**BROOKFIELD STREETScape PHASE II  
STATE PROJECT NO. 0018-0136  
FAP NO. 0202(015)  
TOWN OF BROOKFIELD**

**MAY 2, 2019**

**ADDENDUM NO. 2**

DESIGNED: YL	TITLE: DETAILED ESTIMATE
DRAFTED: PT	SHEET NUMBER: DE-1.A2
CHECKED: RG	
APPROVED:	
SCALE: 1" = 5'	
PROJECT NO.: 2017-0605	
DATE: 03/7/2019	
FILE: Detailed Estimate	
NO. DATE DESCRIPTION	REVISIONS
05/01/19	ITEM NUMBERS AND QUANTITY REVISED

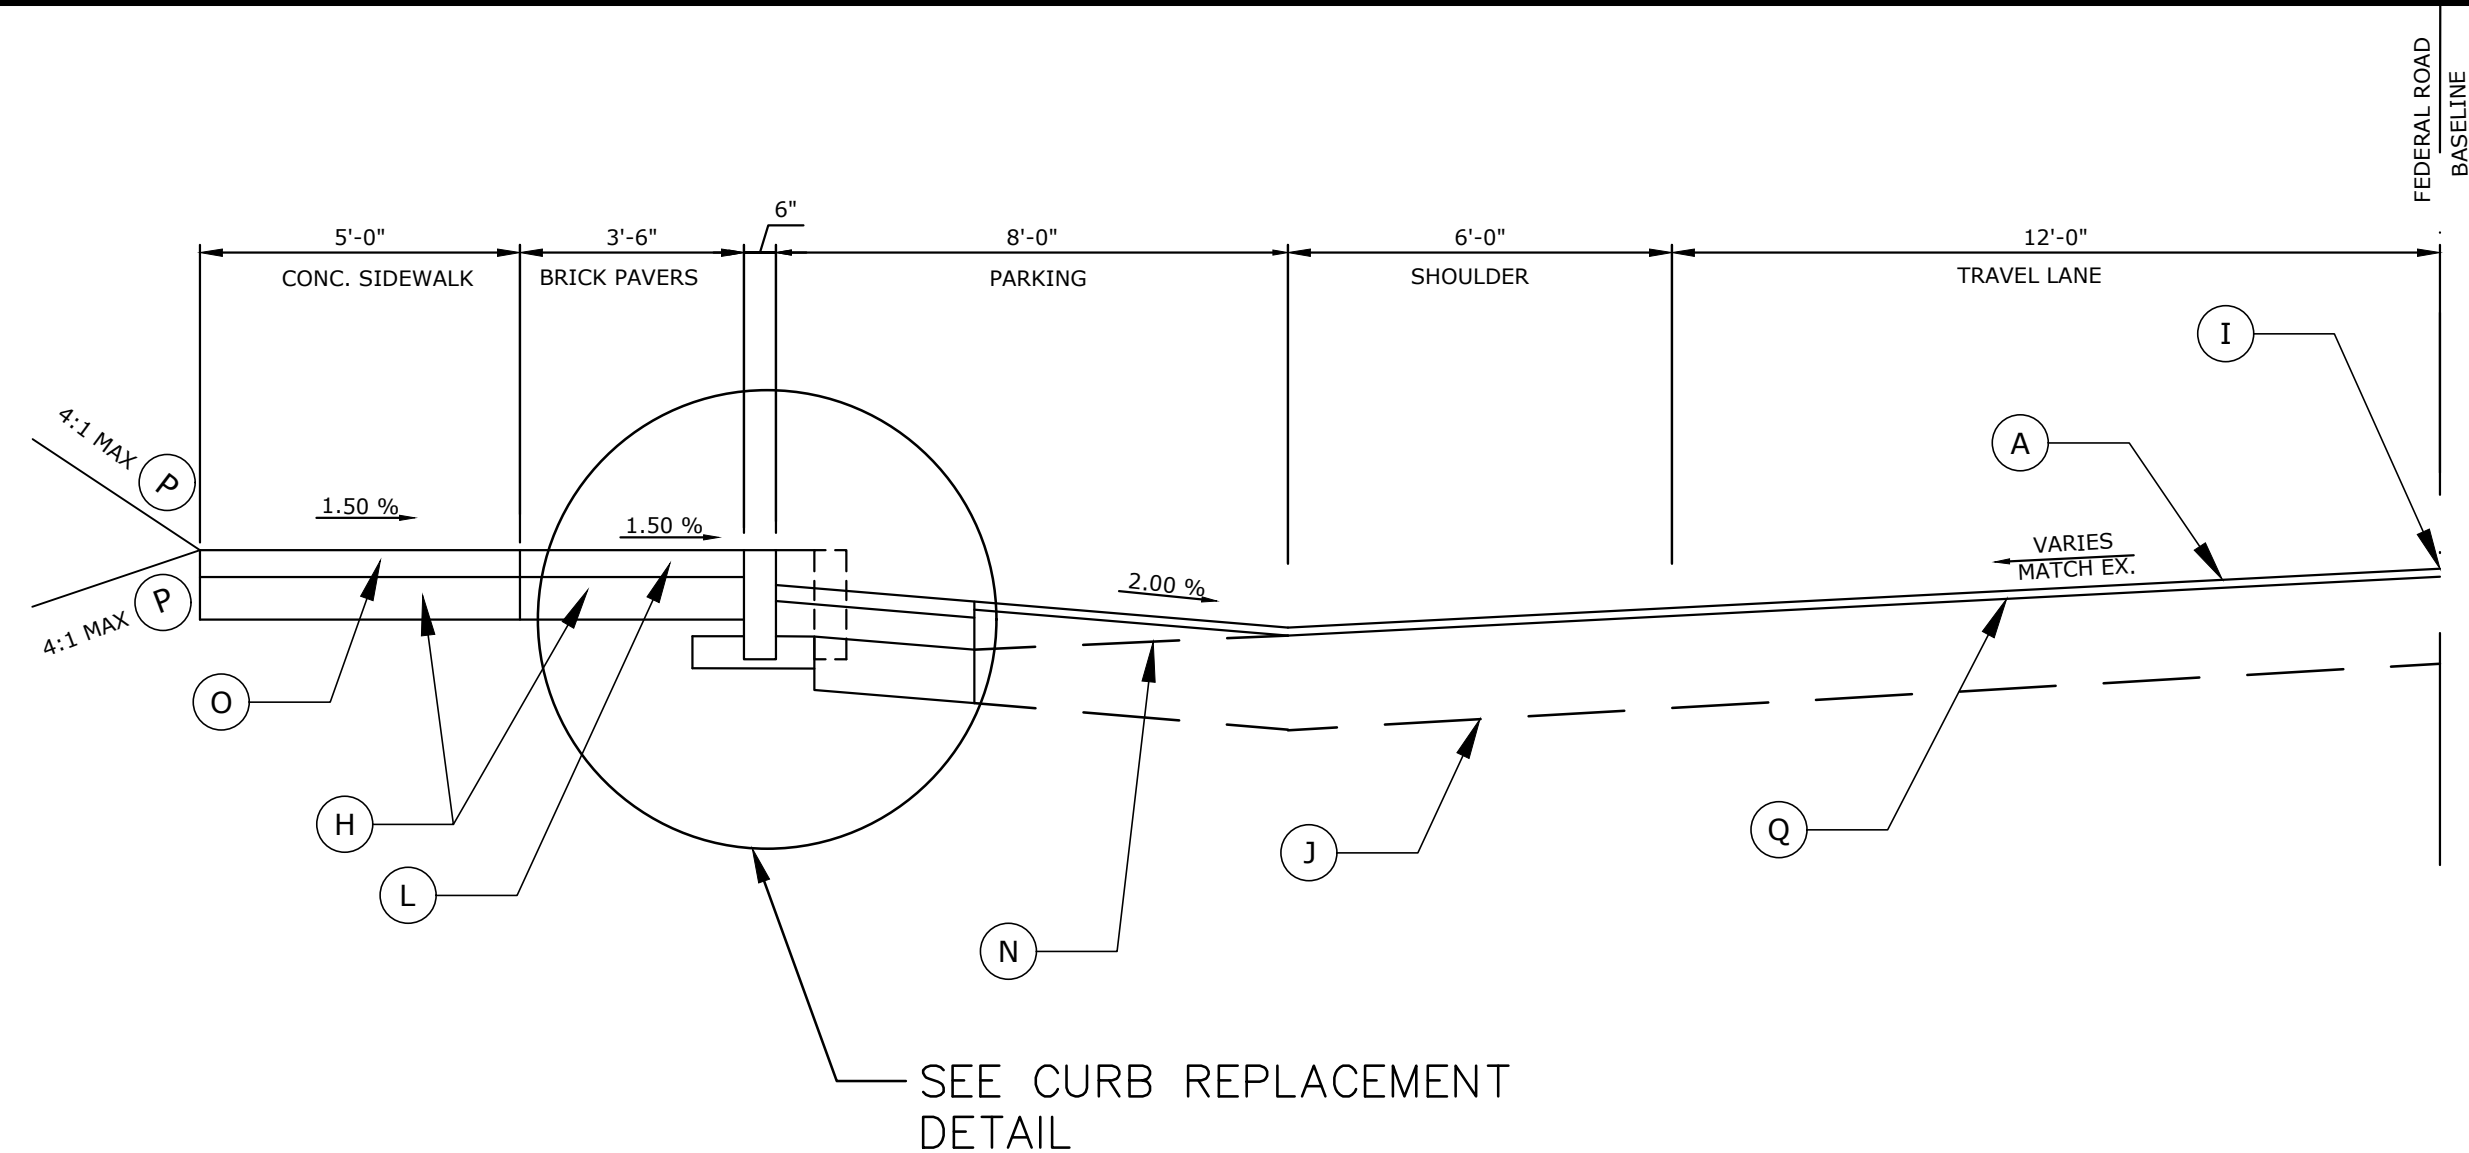
<b>SHEET NO.</b>	<b>SUMMARY OF REVISIONS</b>
<b>TITLE SHEET</b>	<b>General Note Revised</b>
<b>DE-1. A2</b>	<b>Item No. and Quantity Revised</b>
<b>TYP-1. A2</b>	<b>Driveway Slope Revised</b>
<b>TYP-2. A2</b>	<b>Driveway Slope and Legend Revised</b>
<b>MDS-1. A2</b>	<b>Miscellaneous Detail Callout Revised</b>
<b>MDS-2. A2</b>	<b>Miscellaneous Detail Revised</b>
<b>MDS-3. A2</b>	<b>Miscellaneous Detail Added and Revised</b>
<b>HWY-2. A2</b>	<b>Notes, Dimensions and Slope Limit Revised</b>
<b>PRO-2. A2</b>	<b>Catch Basin Type Revised</b>
<b>DRG-2. A2</b>	<b>Catch Basin Type Revised</b>
<b>XSC-1. A2</b>	<b>Brick Paver Width and slope limit Revised</b>
<b>XSC-2. A2</b>	<b>Brick Paver Width and slope limit Revised</b>
<b>XSC-3. A2</b>	<b>Brick Paver Width and slope limit Revised</b>
<b>XSC-4. A2</b>	<b>Brick Paver Width and slope limit Revised</b>
<b>XSC-5. A2</b>	<b>Brick Paver Width and slope limit Revised</b>

DESIGNED: YL	TITLE: TYPICAL SECTION
DRAFTED: PT	SHEET NUMBER: TYP-1.A2
CHECKED: RG	
APPROVED:	
SCALE: NOT TO SCALE	
PROJECT NO.: 2017-0605	
DATE: 04/17/2019	
FILE: HW_MSH_2017_0605_TYP

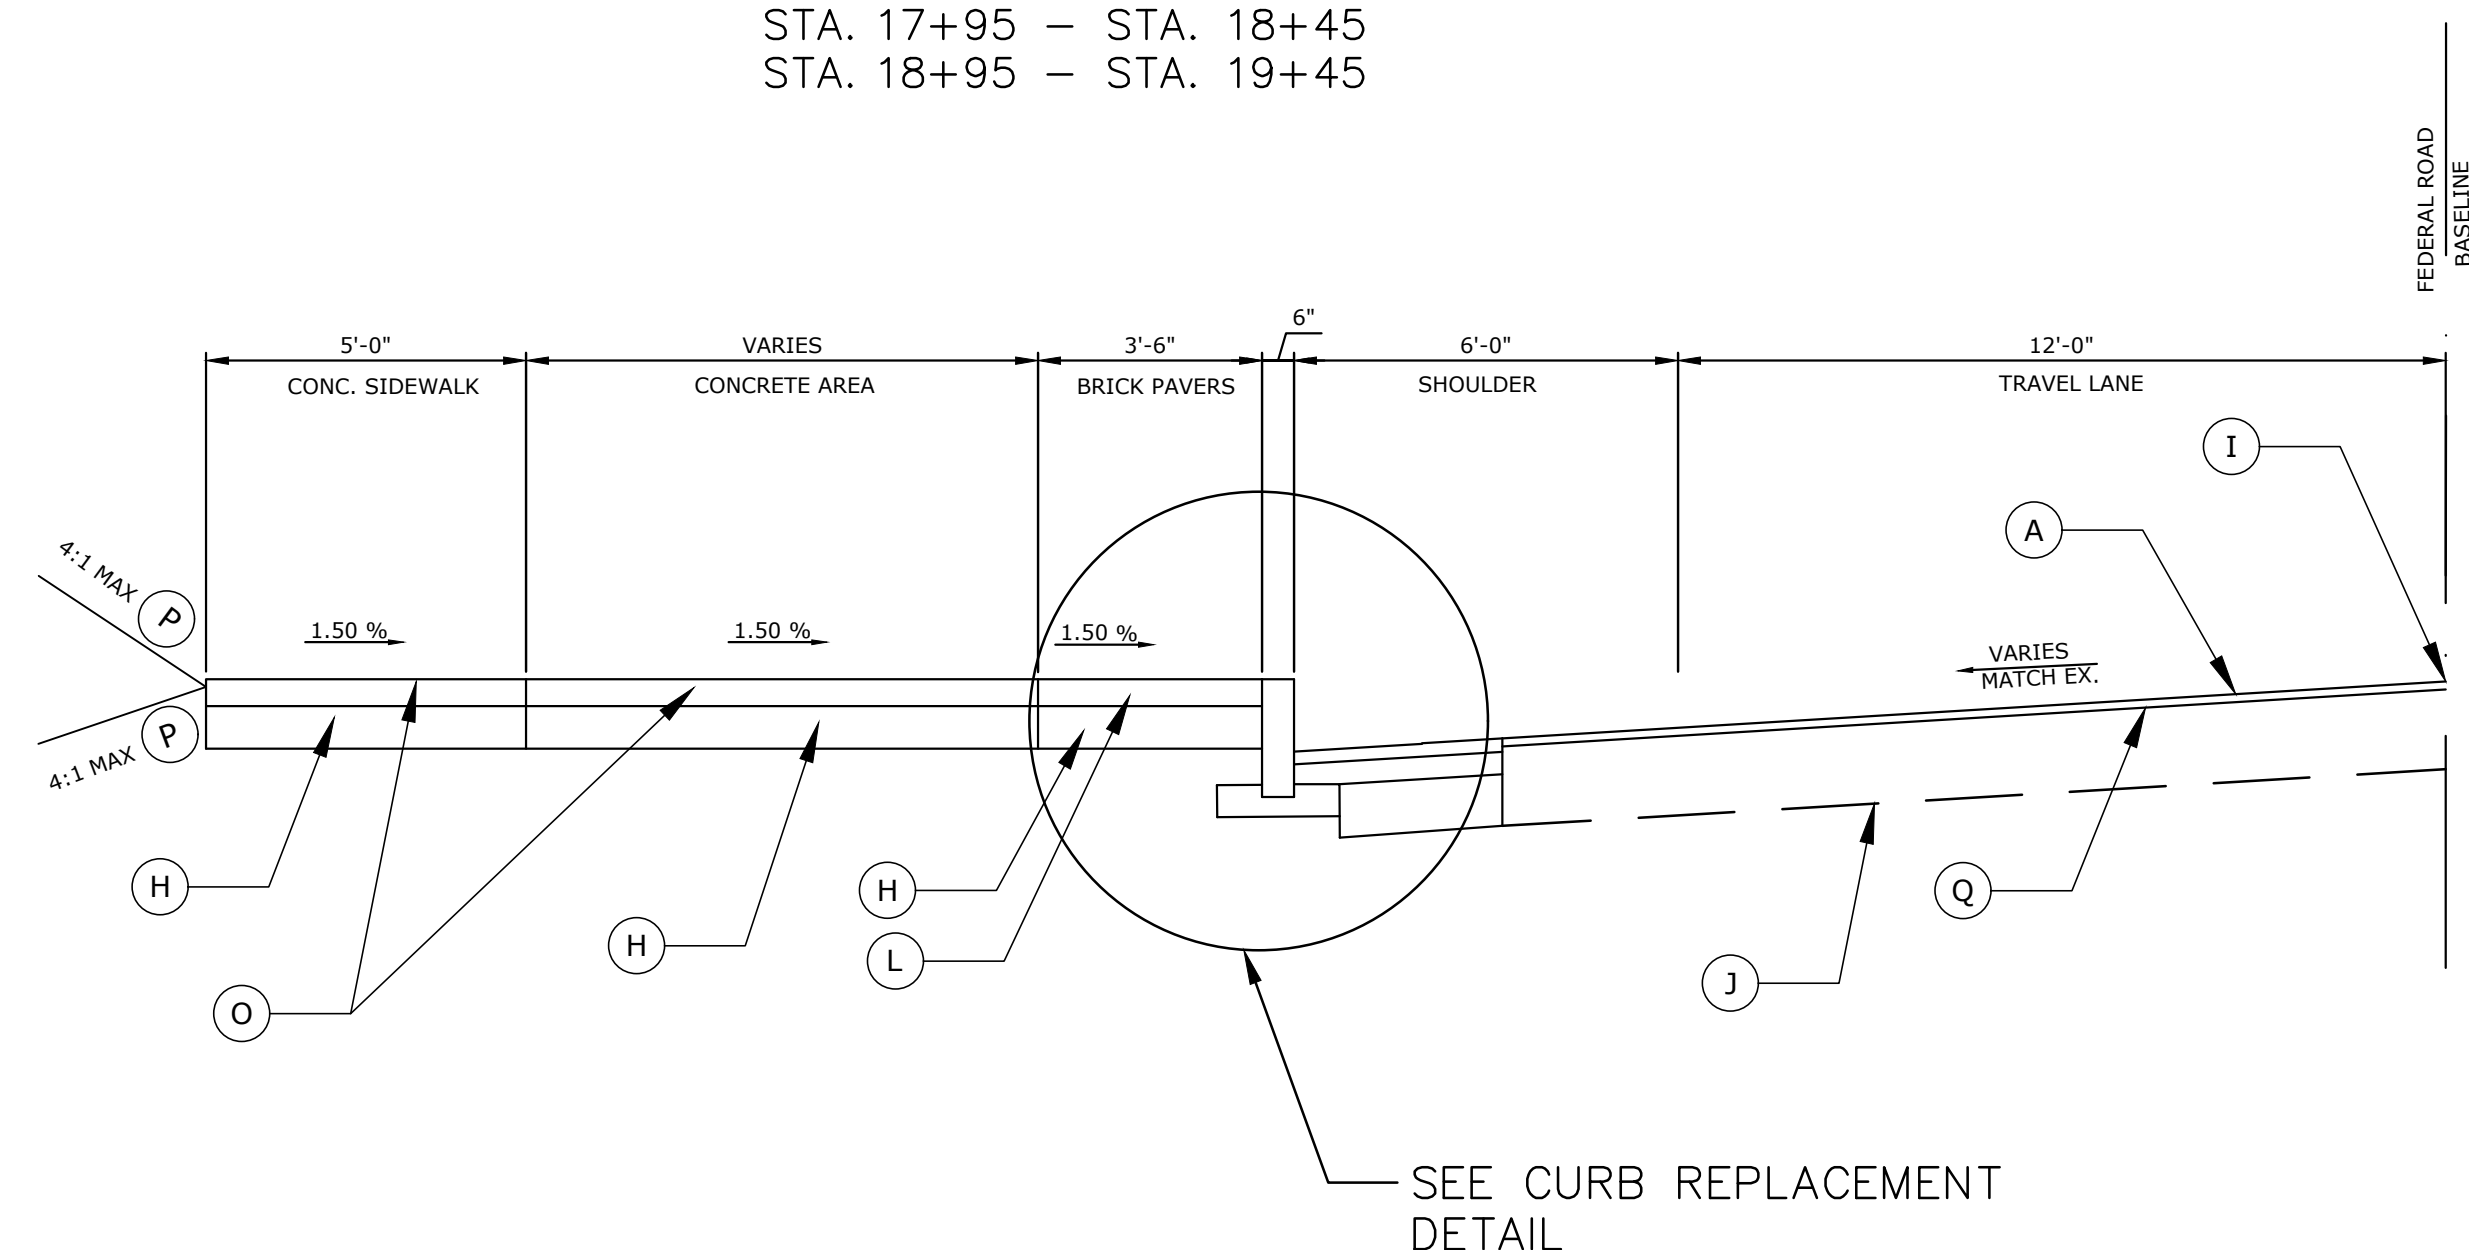
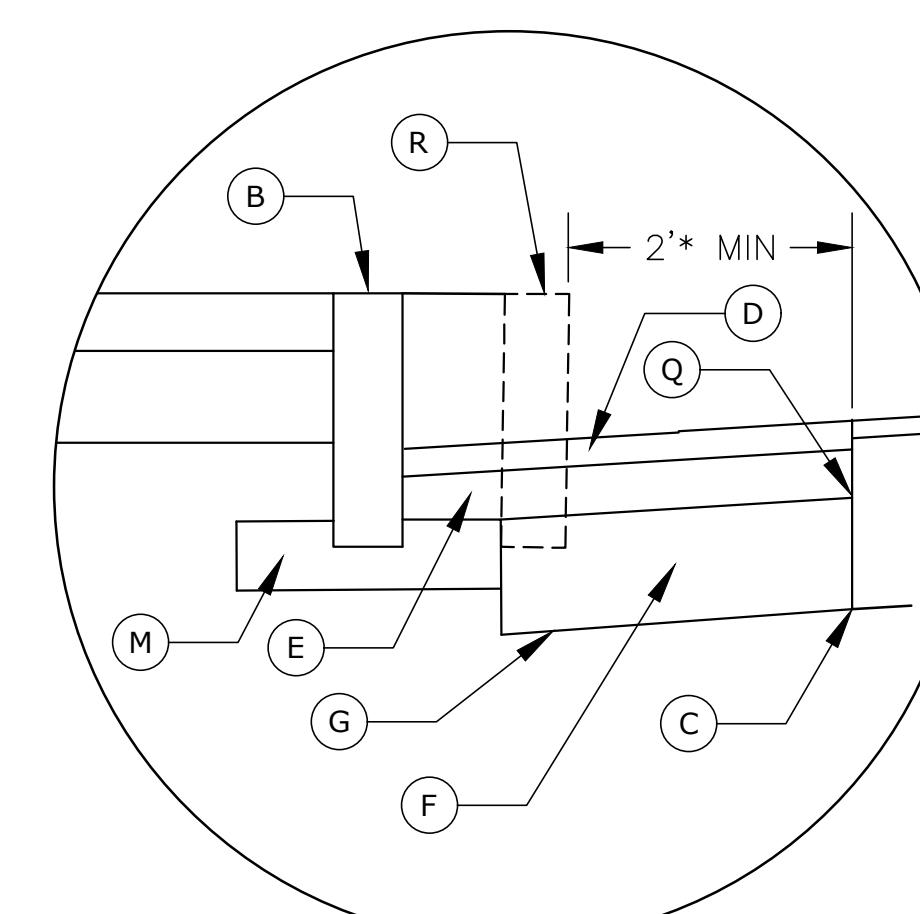
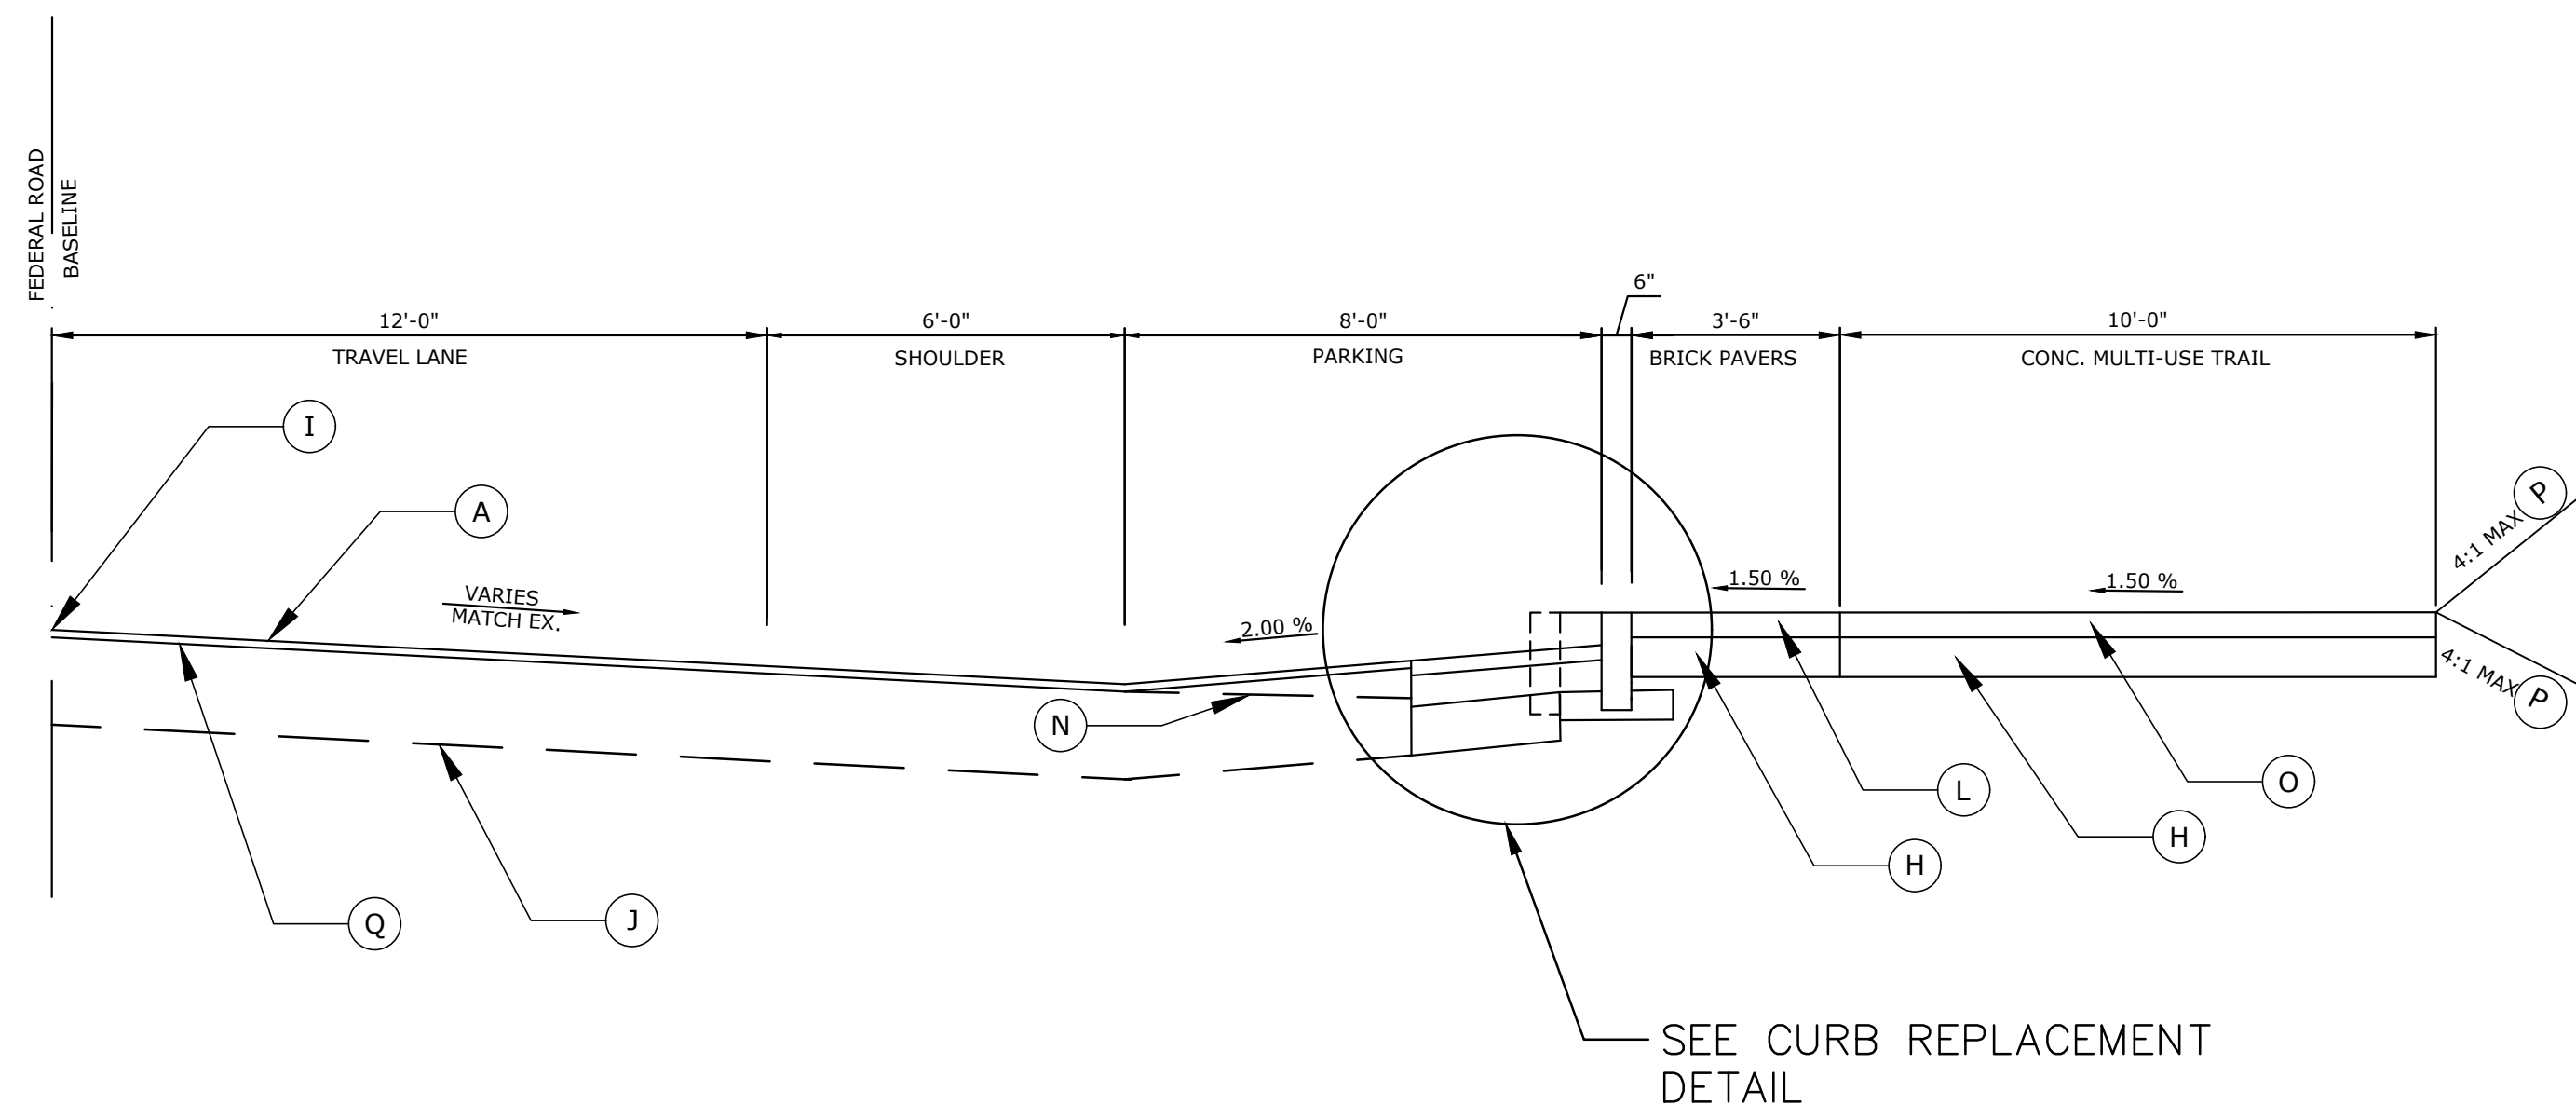
NO.	DATE	DESCRIPTION
05/01/19		DRIVEWAY SLOPE REVISED
		REVISIONS
